HOLDOVER

GULF CREEK SUBDIVISION, RESUBDIVISION OF LOT A, REVISED PLAT OF THE RESUBDIVISION OF LOTS 11 AND 12

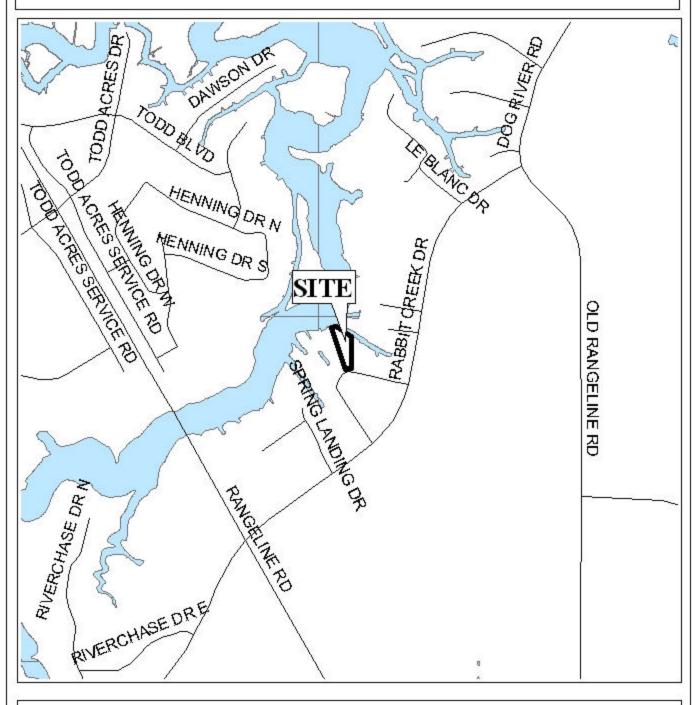
<u>Engineering Comments:</u> Must comply with the Mobile County Flood Damage Prevention Ordinance.

As the site is within the Rabbit Creek watershed, the area may be environmentally sensitive; therefore, the approval of all applicable federal, state and local agencies would be required prior to the issuance of any permits.

The site exceeds the maximum width to depth ratio as recommended by the Subdivision Regulations; therefore, a waiver of Section V.D.3., would be required. Narrow, deep lots are typical along waterways; thus a waiver of V.D.3. would be appropriate.

This site is located in the County, thus a note should be placed on the final plat stating that any lots which are developed commercially and adjoin residentially developed property must provide a buffer, in compliance with Section V.A.7. of the Subdivision Regulations.

With modifications and a waiver of Section V.D.3. for the site, the plat meets the minimum requirements of the Subdivision Regulations and is recommended for Tentative Approval subject to the following conditions: 1) the approval of all applicable federal, state and local agencies prior to the issuance of any permits; and 2) the placement of a note on the final plat stating that any lots which are developed commercially and adjoin residentially developed property must provide a buffer, in compliance with Section V.A.7. of the Subdivision Regulations.
